Urban Design Review Panel Report

500 Coventry Road, Ottawa

**RE: Urban Design Review Panel Report
Site Plan Control Application
500 Coventry Road, Ottawa**

Urban Design Review Panel - Formal Review

Master Plan - Conceptual Option 2 (Preferred)

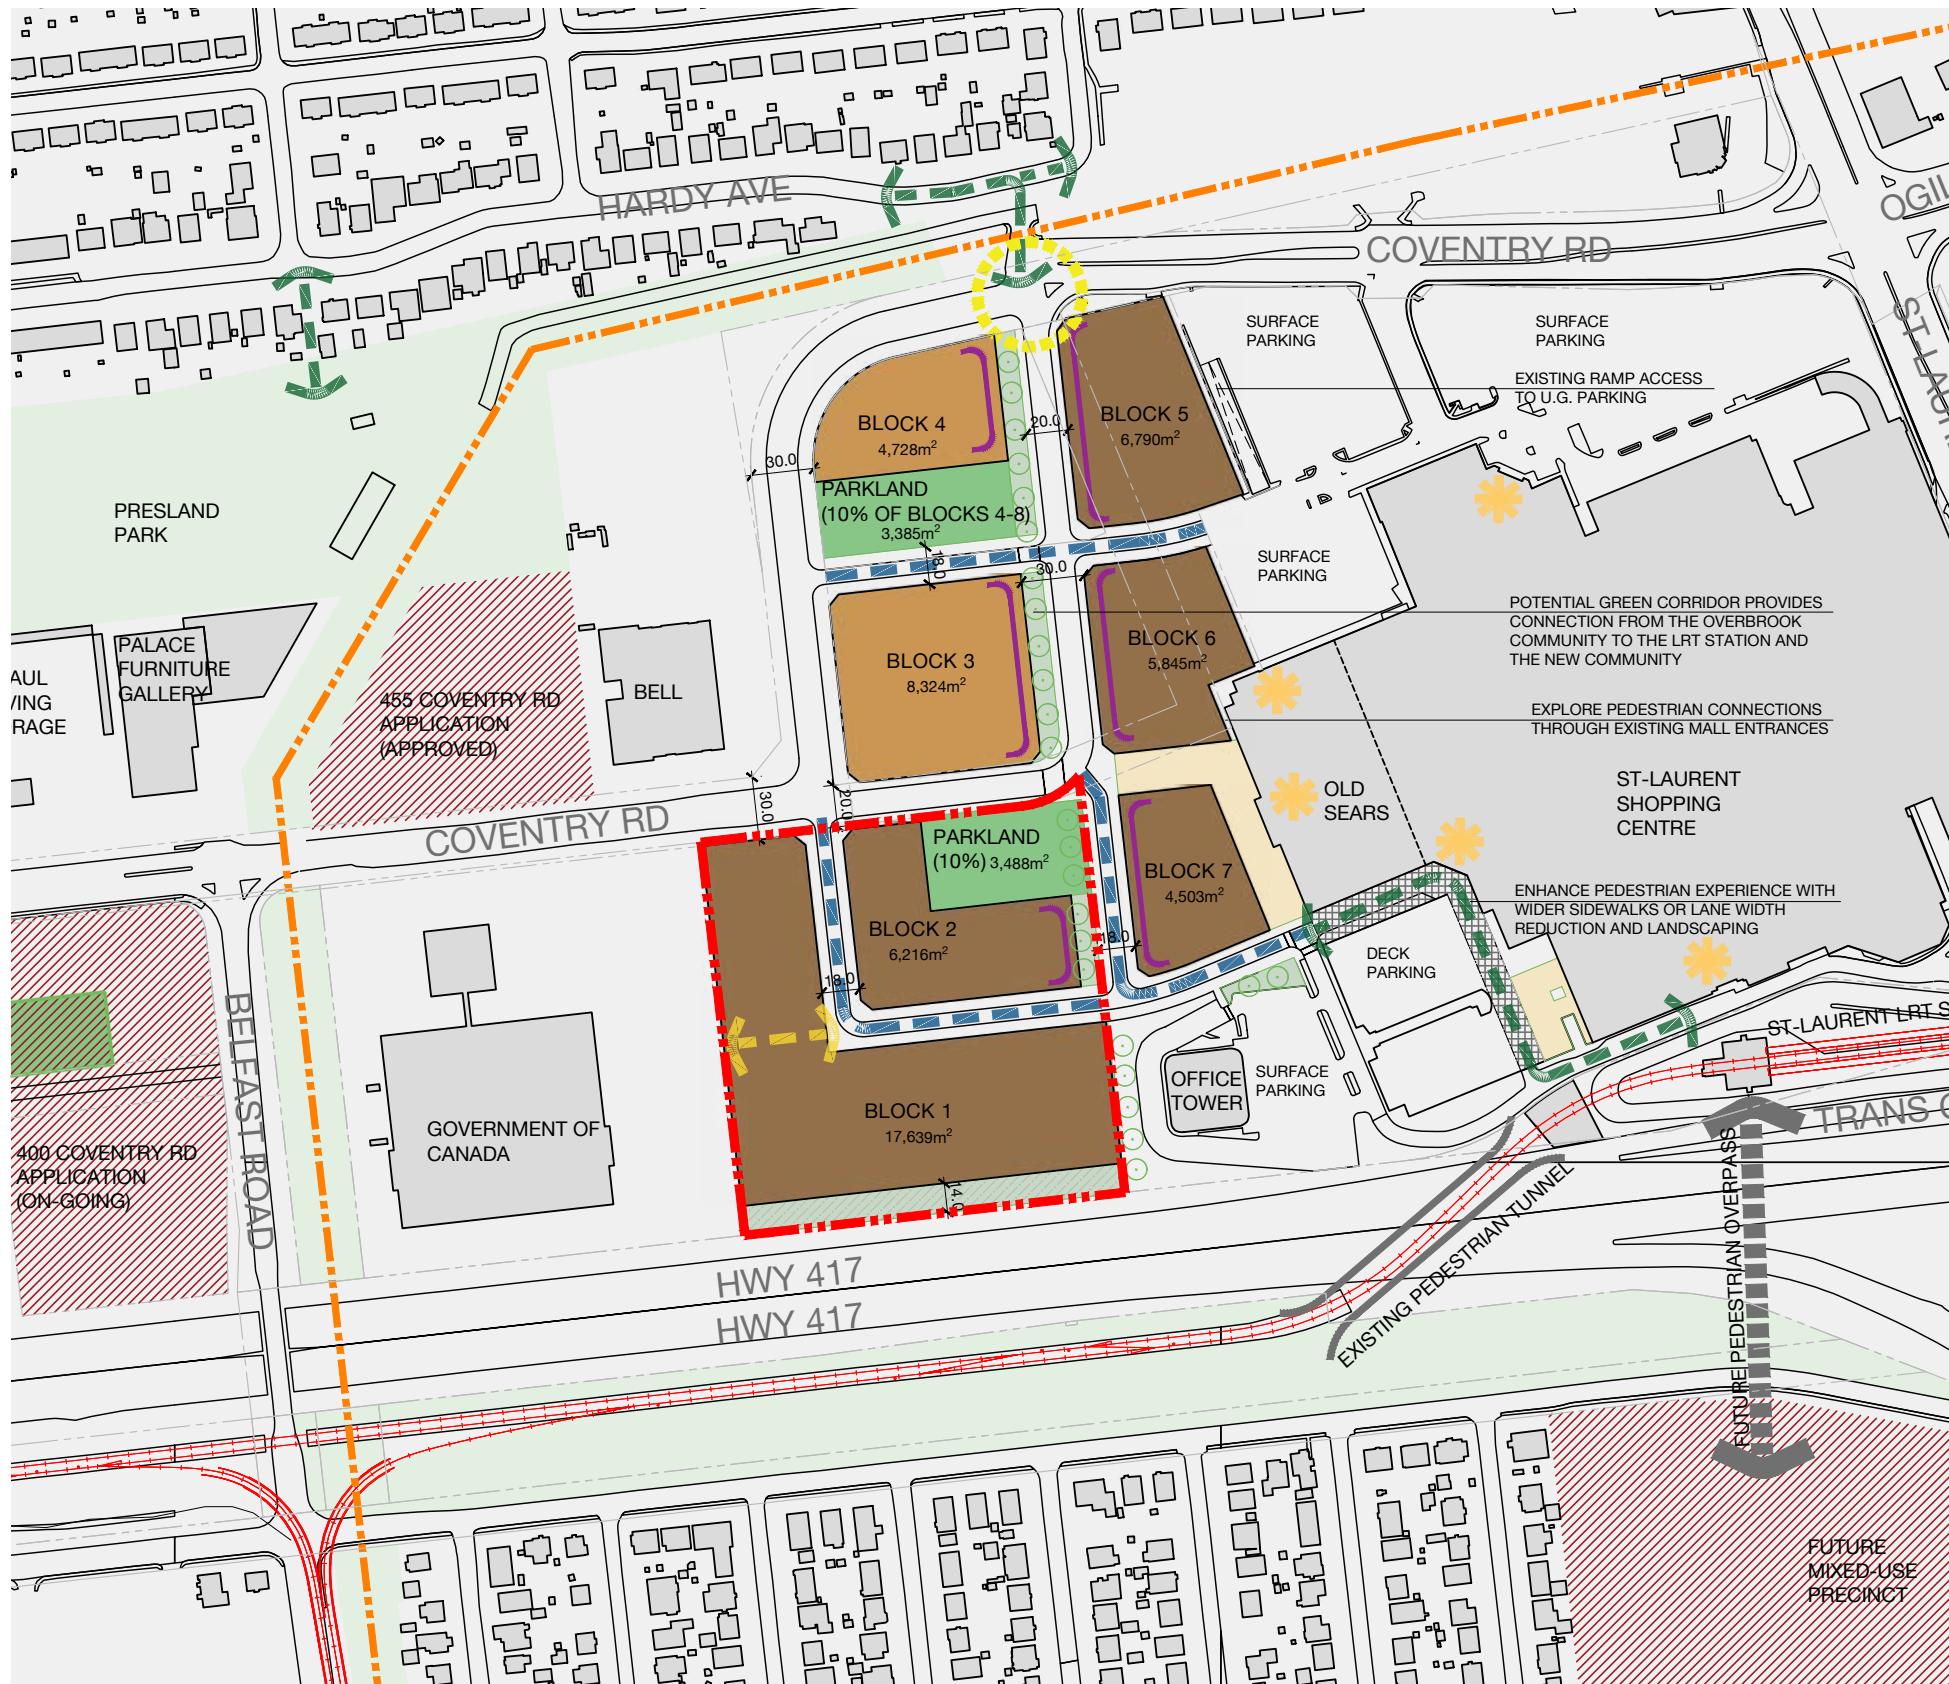
17. The Panel recommends pursuing 'Option 2' for the overall site master plan.

Response: Acknowledged.

Master Plan - PHASE 1

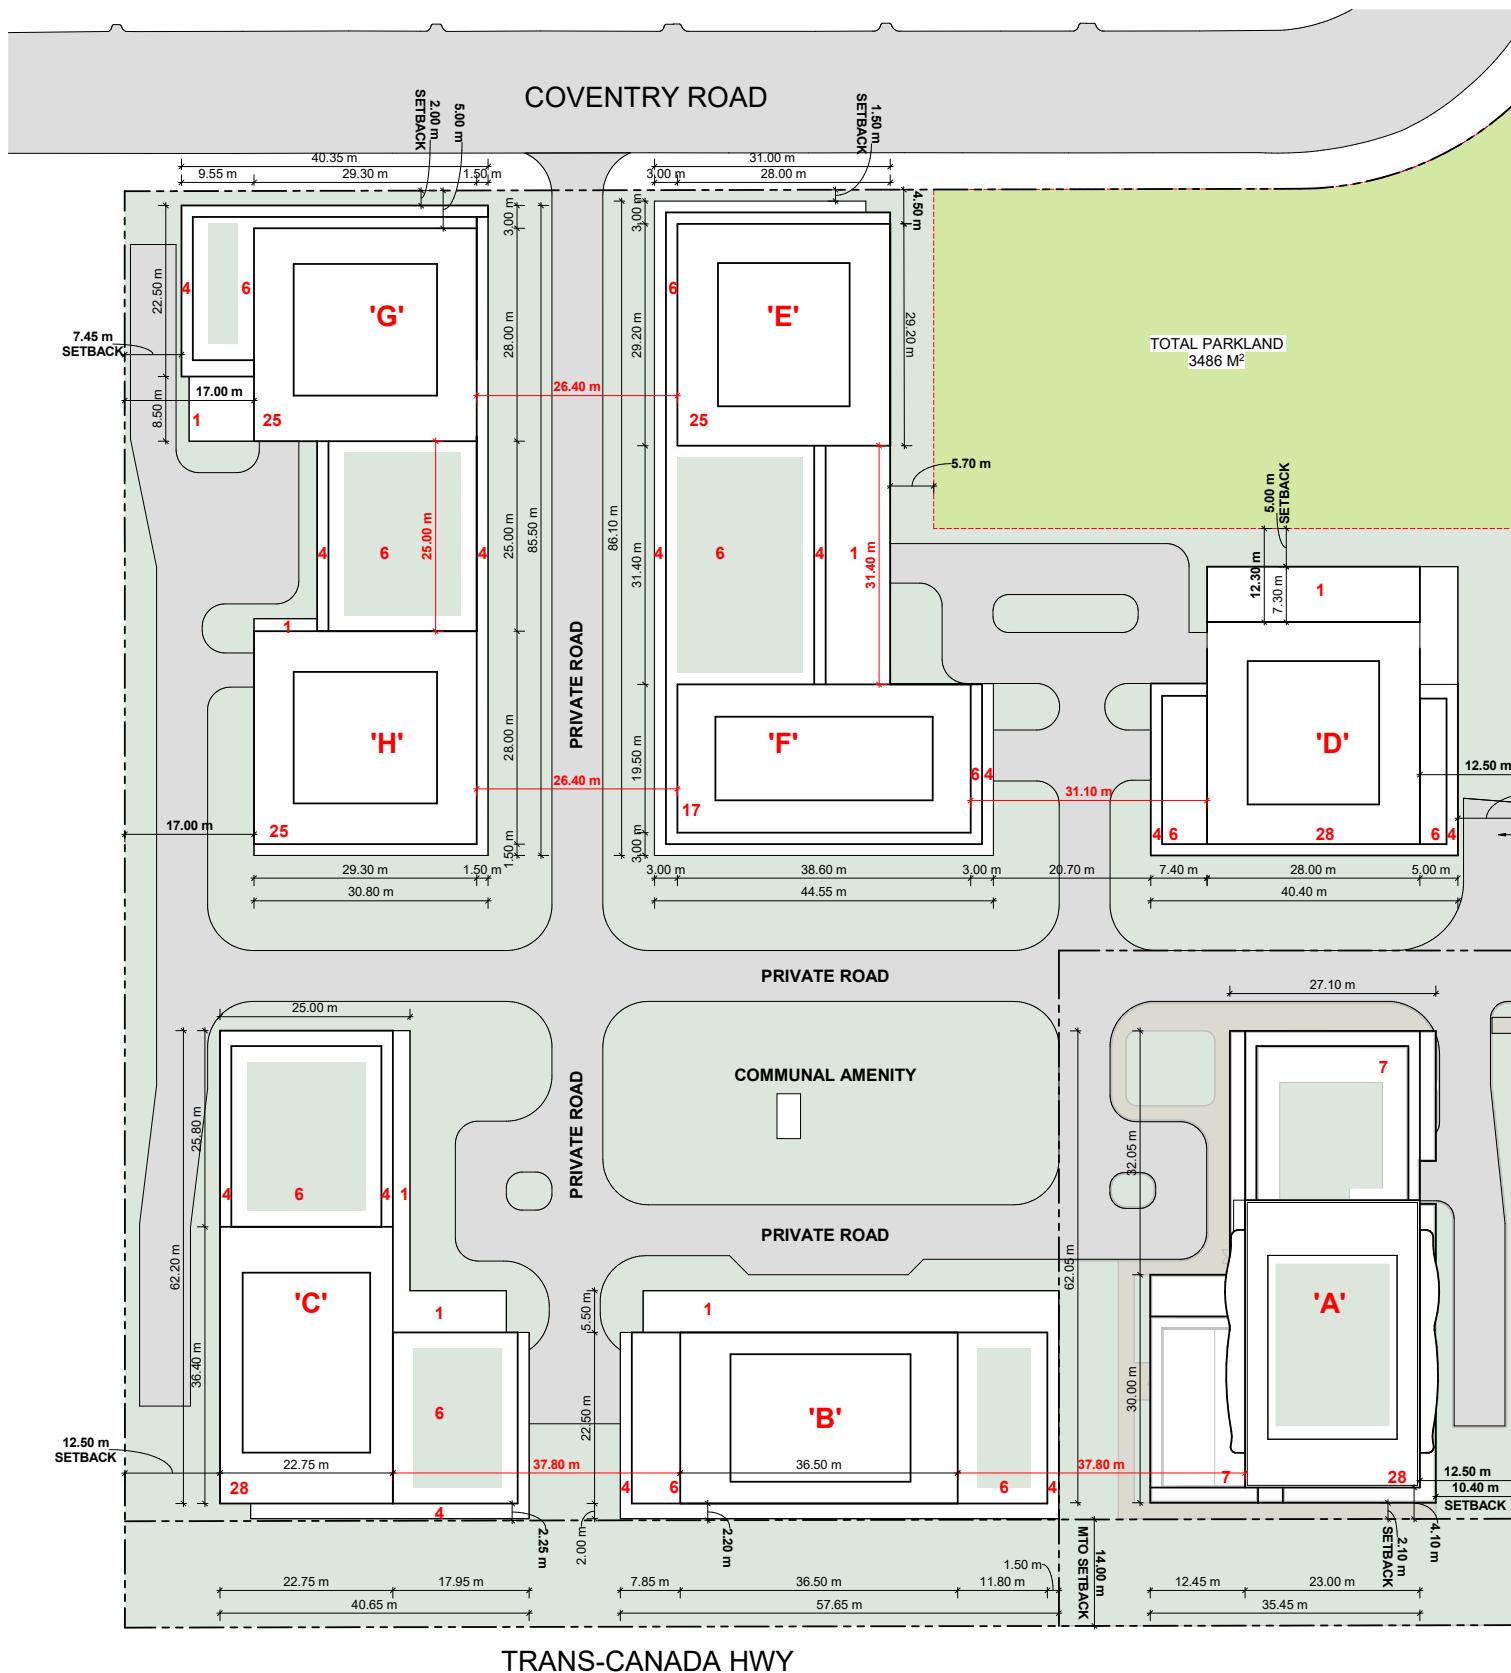
2. The Panel strongly recommends more thought be given to creating a pedestrian-first built environment and layering to the Phase 1 Master Plan presented (p.26), as it currently appears overly vehicle oriented.

18. The Panel has concerns with how vehicle oriented the Phase 1 Master Plan (p.26) appears to be, and strongly recommends the loading and drop-off areas be located closer to the two main private roads. As currently designed, the loading and drop-off areas are too deep into the sites and not optimizing land use for a pedestrian-first environment.

- Consider providing valuable pedestrian mid-block connections and linkages to the mall and park along the east and west edges of the Phase 1 Master Plan (p.26).

- Consider the role of architecture as a terminus/anchor to long views, building on the 'tower in the park' approach to buildings A, B, and C (p.26).

36. The Panel recommends towers A, B, and C (p.26)—the three closest to highway 417—need not be designed in the typical tower-podium relationship/typology.

- The Panel suggests towers A, B, and C, could conform to a ‘tower in the park’ typology, in order to free up more of the ground plane for community park/amenity spaces (e.g., finger parks) and help interconnect the ground plane with a pedestrian-first tree-lined green network.

Response: Master plan design has been revised to be more pedestrian oriented with less paved road. Refer to sheet SPA005A.

Response: Acknowledged.

Response: Communal amenity areas have been proposed at the terminal of each long views, with the potential to add landscape and public features. Refer to sheet SPA005A.

Response: Community park and amenity spaces have been thoughtfully integrated into the master plan design, with the intention to active the ground plane and connect buildings. Refer to sheet SPA005A.

Elevations

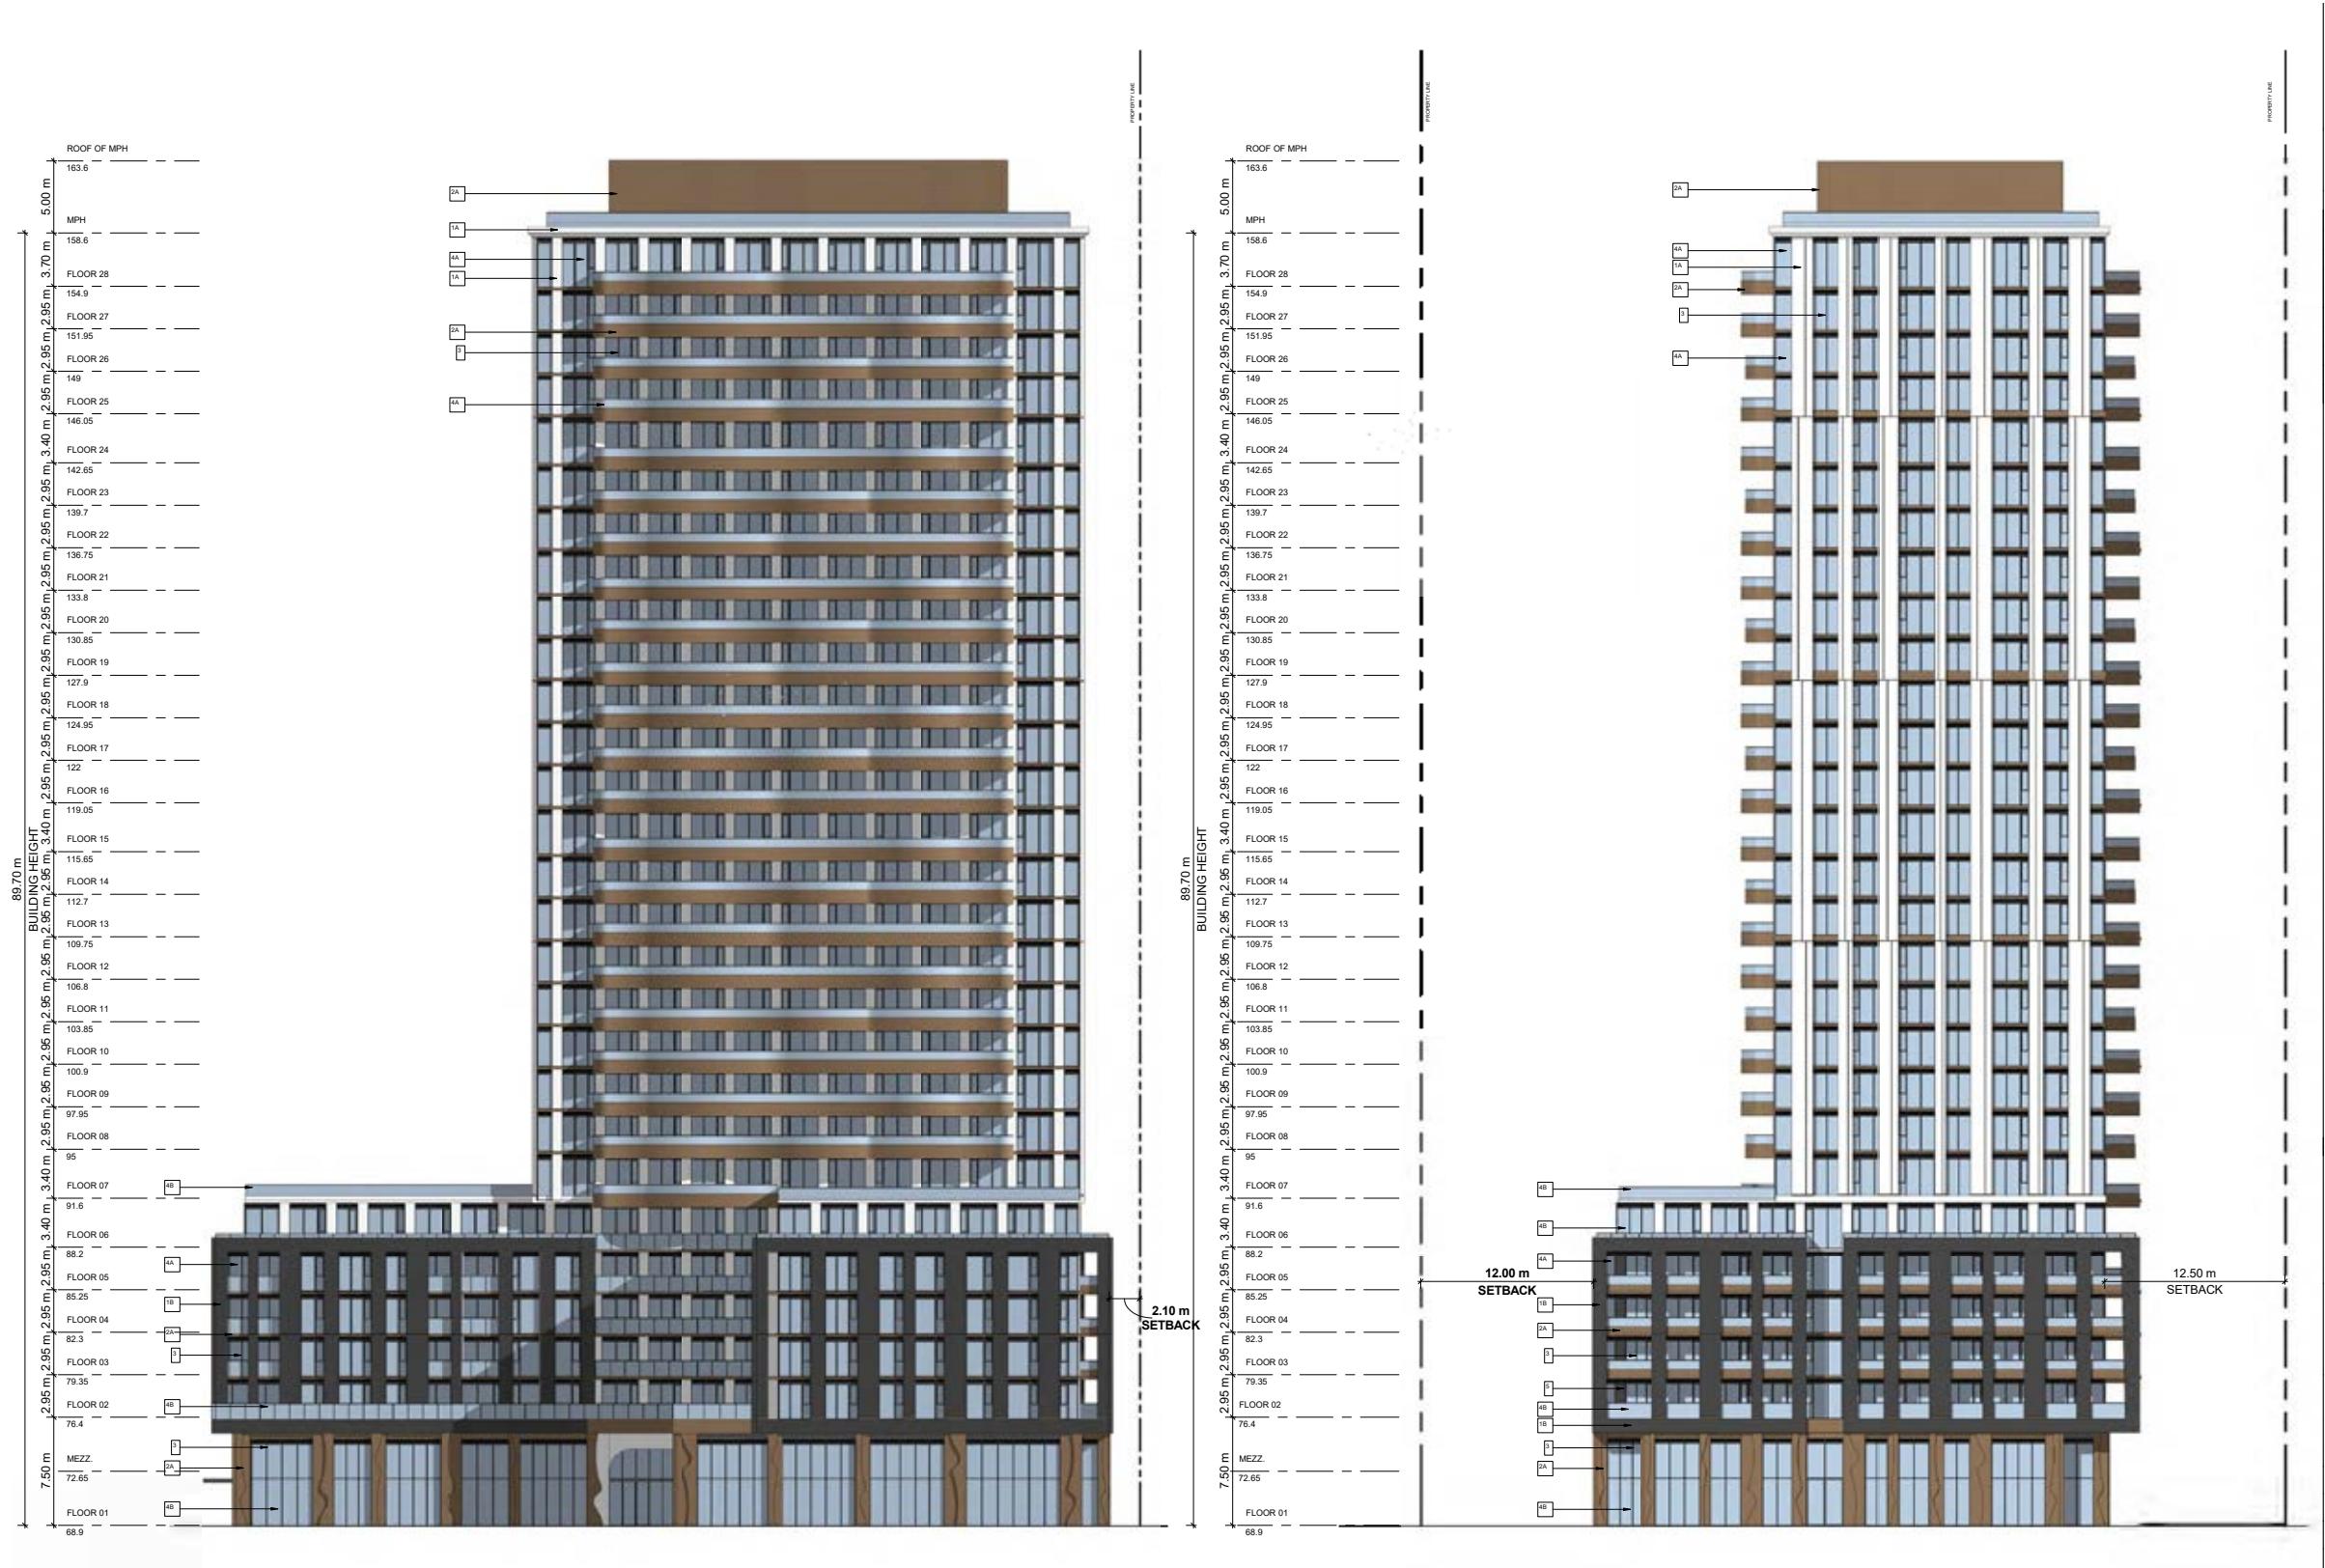
10. The Panel recommends furthering the undulating balconies and water motif to the north and south elevations to create a play between the orthogonal and undulations.

31. The Panel appreciates the water motif of the tower's architectural expression. The undulations are particularly appreciated with great potential for capturing and playing with light.
 - The Panel recommends leaning more into the undulating balcony articulation to further advance the waterfall motif.
 - The Panel recommends wrapping the undulating balconies around onto the north and south elevations of the tower, at least partially if not fully.

32. The Panel has some suggestions to reduce the contrast between the vertical pre-cast white strips on the elevations, and the undulating balconies of the east and west elevations.

- The Panel recommends as one approach, adding a softness to the vertical white pre-cast element, and further exploring how this waterfall motif could also be integrated to soften the vertical strips.

Response: We appreciate the suggestion. The undulation of the balconies is intended to achieve a certain effect on the east and west elevations mainly and are purposefully not being proposed on North and South elevations to achieve a contrast and maximize the effect where they are being proposed.

Response: We appreciate the suggestion. The undulation of the balconies is intended to achieve a certain effect on the east and west elevations mainly and are purposefully not being proposed on North and South elevations to

achieve a contrast and maximize the effect where they are being proposed. We purposefully located balconies where needed and prefer limiting the amount of slab projections where not necessary.

Response: We appreciate the suggestion. As we continue to refine the design we will consider if a stone-like material can be used to anchor the waterfall motif as suggested.
